Memorandum

13-Sept.-2007

**Subject: Further Discussion of the External Corrosion
 on the Drywell Shell in the Sandbed Region.**

Figure 1

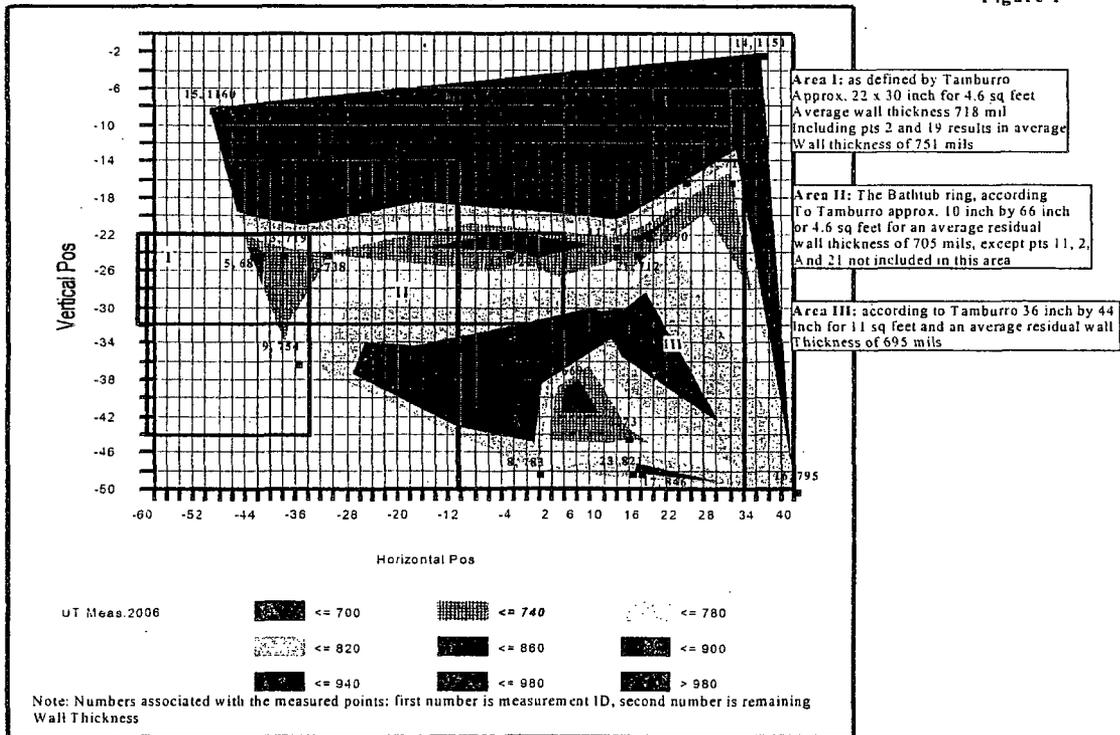
The resulting contour plot is shown in Figure 1. We have inserted the measurement ID's for each point as well as the respective remaining wall thicknesses. Additionally, we have superimposed Mr. Tamburro's evaluation, which is merely a coarse manual version of the contour plot.

Tamburro in Fig. 1-2 (Ref. 4) defines three areas as shown in Fig.1 below for individual evaluation. Thus Area I contains points 5, 9 and 13 for an “average thickness of 718 mils in an area of 22 inch by approx. 30 inch, or 4.6 sq. feet. Strangely, in Fig 1-6 of Tamburro’s work, the same area (referenced in Fig. 1-2) was narrowed and elongated to also contain points 4 and 19. The average residual thickness now was increased to 751 mils, while the estimated area was reduced to 23” by 16” or 2.6 square feet. Fig. 1 below, illustrates that the crude manual estimation by Tamburro is a coarse approximation to the surfaces generated by contouring. The advantage of using the computer is that the manual method is vulnerable to observer bias and does not provide an objective test of whether the results meet the local area acceptance criterion.

Next, Tamburro defines in Fig. 1-2 an area, which he dubs the “Bathtub Ring”. Curiously, he does not include points 11, 2, and 21 in this area even though they are clearly part of the bathtub ring (see Fig. 1 below), but includes these points in another area, which we identified as area III in Fig. 1 below. But when this area (Area III in our Fig. 1) is discussed by Tamburro in his Fig 3-1 (page 30 Ref. 4) he is not consistent in the dimensions. Nevertheless, he identifies this area as the 736 mil boundary and inserts in the same graph a 636 mil boundary somewhat arbitrarily in the middle. Now, Tamburro has identified an area of 14 x 18 inches in his Fig 1-3 as having an average wall thickness of 696 mils (points 7, 11 and 21) and being 1.75 sqft in area. But curiously, point 6 (clearly a companion point to 7 and certainly part of a corroded area) is left out of this exercise.

There are, however, other, more serious slights of hand in the Tamburro evaluation. In Fig 1-4 (Ref. 4 pg 31) he compares the area covered by points 2, 7, 11 and 21 to the local buckling criterion. He tells us that the area covered by these points is 7 inch by 4 inch or only 0.2 sq feet, when it can easily be seen from our Fig 1 below that the

area attributed to these points would be of the order of 18 by 14 inches or nearly 2 sq feet. Figure 1-4 is therefore incorrect. The same error is repeated in Tamburro's Fig 1-5.

And when it comes to the bathtub ring (Fig. 1-6) and an assessment of points 5, 13, and 4 he conveniently adds points 9 and 19 (see Fig. 1 below) to arrive at an average wall thickness of 751 mils. There is no obvious justification for including point 19 in the bathtub ring. Without it the average would have been 722 mils over an area of about 14 by 14 inches or 1.4 sq ft.

When all is said and done, Tamburro rearranges the data again in Fig. 1-7 and finds an area of 9 sq feet that has a residual wall thickness of 696. However, as clearly shown on Figure 1 this Fig. 1-7 is again incorrect because the area selected must actually be at least 42 inches by 36 inches to capture all the points show on Fig. 1-7, which is considerably larger than 9 square feet.

3. Figure 1-7, perhaps inadvertently, illustrates that, according to Tamburro, an area of average thickness 0.696 inches extends over an area that is larger than 9 square feet. Based on this assessment, Tamburro should have concluded that the drywell failed the local area acceptance criterion he was using, which required contiguous areas that are thinner than 0.736 inches on average to be less than 9 square feet in extent. It is unclear why he arbitrarily labeled the area as 36 inches by 36 inches.

Figure 2

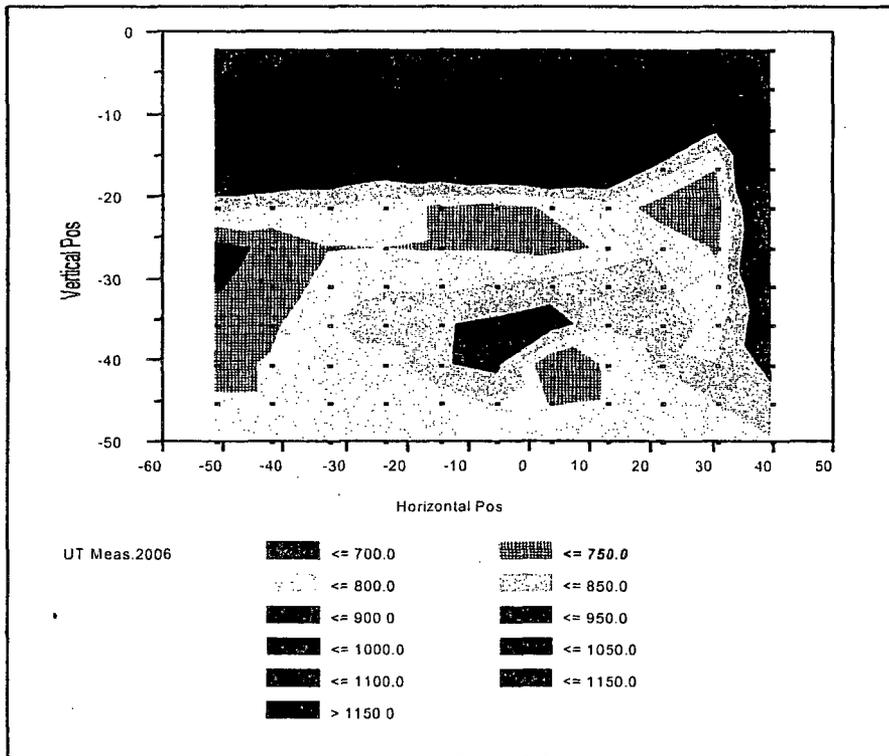
The triangulation, on the basis of which the response surfaces are generated, first generates the equations (correlation functions) used to draw the contours. These same equations can then also be used to define a grid larger than the area that had actually been covered by measurements, and to extend the contours for the purpose of predicting, in this case, the extent of corrosion one might expect outside the measured areas. This was done in Figure 2 below for Bay 1. The reason why this was done was because it was suspected that the bathtub ring might extend away from the vent line into the center of the bay. Indeed, as can be seen from Figure 2, a large area of about 15 by 20 inches might exist with a residual wall thickness of less than 750 mils and might actually extend into Bay 19. This is a prediction based on the existing data, and if verification of this prediction is outside the scope of the present intervention, it is certainly a better prediction than the assumption that corrosion stopped with the evaluation of points 5 (680 mils), and 9 (745 mils) 30 to 35 inches below the top of the sandbed.

We also see from Figures 1 and 2 that at the top of the sandbed essentially no corrosion occurred. This is in agreement with the internal grid measurements which essentially showed the same thing, **and which is in part the reason why we have concluded earlier that the internal grid measurements do not reflect the corrosion in the sand bed area and are not in anyway representative of the corrosion of the drywell liner.**

Figure 3

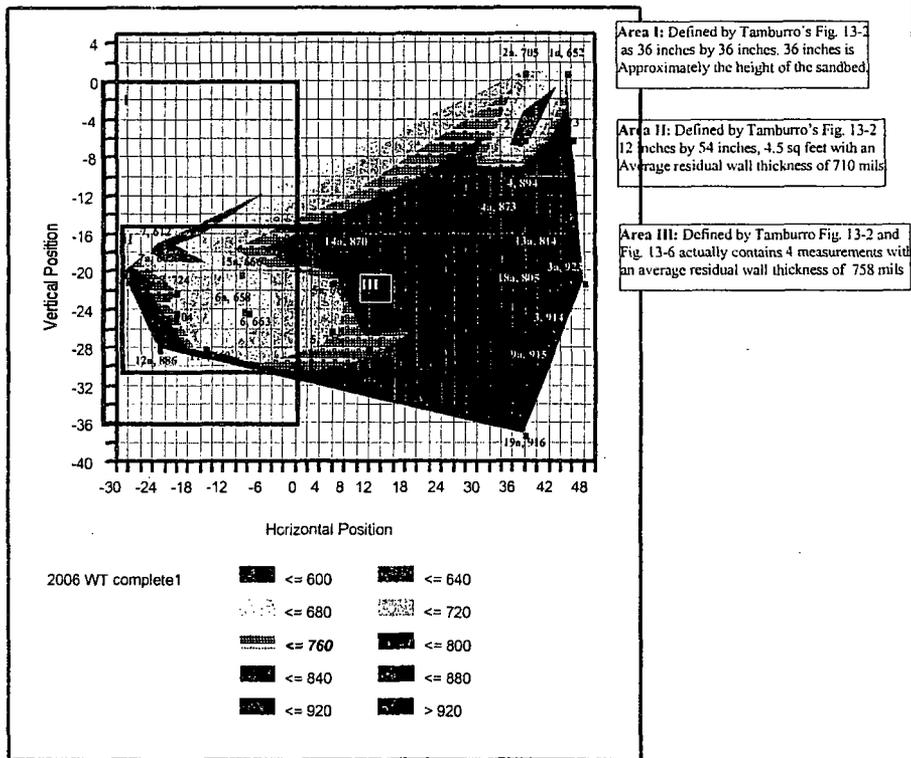
In 2006 it was reported that a number of the location identified in 1992 could not be "found" and therefore no 2006 data were reported for these locations. This was most unfortunate, because it appeared that one could not now deal with the spots of severe corrosion in the upper right hand corner of Figure 3. However, since it had been observed that on average all 2006 data were 20 mils lower than the 1992 results, the missing 2006 data were filled in with the corresponding 1992 data reduced by 20 mils. These "calculated" measurements are shown in the last column in Table 2 below in italics. Since there were duplicate measurements at the same coordinates, in some cases the coordinates of the second set of data were slightly shifted in order to include all data in the contours ⁶⁾

Figure 3 below thus shows the response surface for the 2006 external UT measurements in the sandbed region. Superimposed are the three areas, I, II, and III, which Tamburro proposed in order to analyze Bay 13 corrosion in greater detail. Tamburro locates all measured points in an approximate graph of Figure 13-1 on page 63 of Ref. 4. It is noted first of all that the relative position of the individual points is distorted when compared to Fig. 3 below which is drawn with the accurate coordinates. Second, as one looks at the numbering of the points it is hard to believe that an argument could be made that the points to be measured **had not been selected at random**. Finally, we also notice that all measuring locations are indicated in Fig. 13-1, however, as we proceed to examine Tamburro's individual areas we find that for some unexplained reasons some of the most corroded points are left out. Thus within the three areas Tamburro proposes to discuss in Fig. 13-2 we find that points 1 and 2 and 1a and 2a are missing. Clearly, the absence of these heavily corroded areas from Tamburro's analysis grossly distort his conclusions.

Tamburro and AmerGen have insisted all through these discussions that the most heavily corroded areas had been selected for UT measurements, and that their evaluation were conservative. However, in the final analysis the most heavily corroded areas are simply overlooked. It turns out that the bathtub ring in Bay 13 is not horizontal, but tilted toward the center of the bay.

Area I: Defined by Tamburro's Fig. 13-2 as 36 inches by 36 inches. 36 inches is approximately the height of the sandbed.

Area II: Defined by Tamburro's Fig. 13-2 12 inches by 54 inches, 4.5 sq feet with an Average residual wall thickness of 710 mils

Area III: Defined by Tamburro Fig. 13-2 and Fig. 13-6 actually contains 4 measurements with an average residual wall thickness of 758 mils

Figure 4

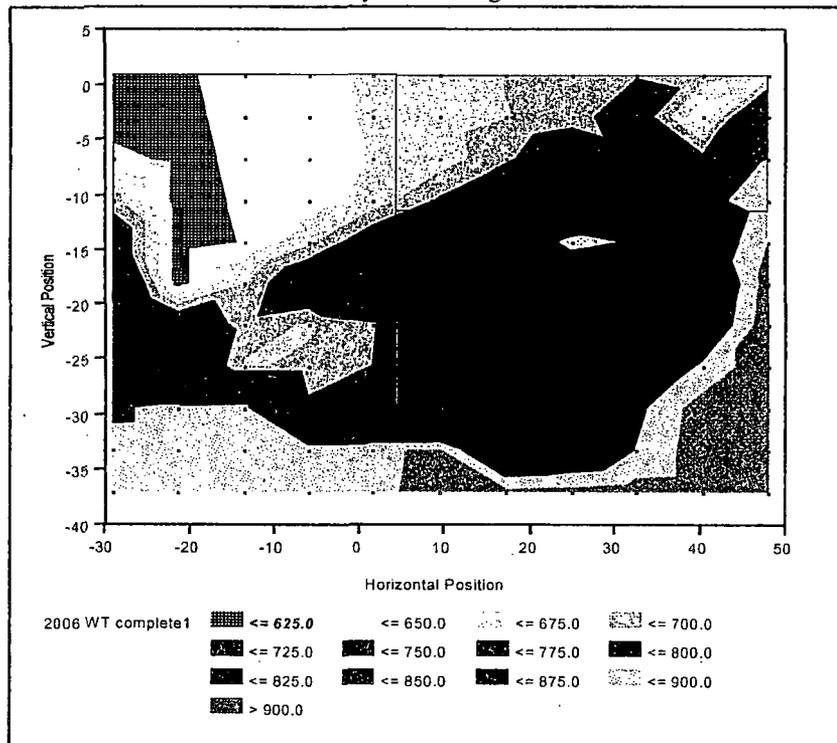
Figure 4 shows the predictive contours derived from the triangulation correlations. Note, that the areas predicted to have less than a residual wall thickness of 750 mils (dark green shading) extend all the way up to 0 on the scale of vertical coordinates, a few inches below the "internal grid measurements." Three internal grids had been measured in this Bay (Ref. 11, Section 6, Table 6) with average residual wall thicknesses of 846 (13A), 904 (13D bottom), 1047 (13 B top) and 1142 (13 C). Thus, it is likely that the internal measurements are mostly above the angled bathtub ring, which is tapering out at 11'3" or thereabouts. **Clearly, however, none of the Internal Grid UT measurements reflects the severity of the actual corrosion in the sandbed area below 11'3" in Bay 13.**
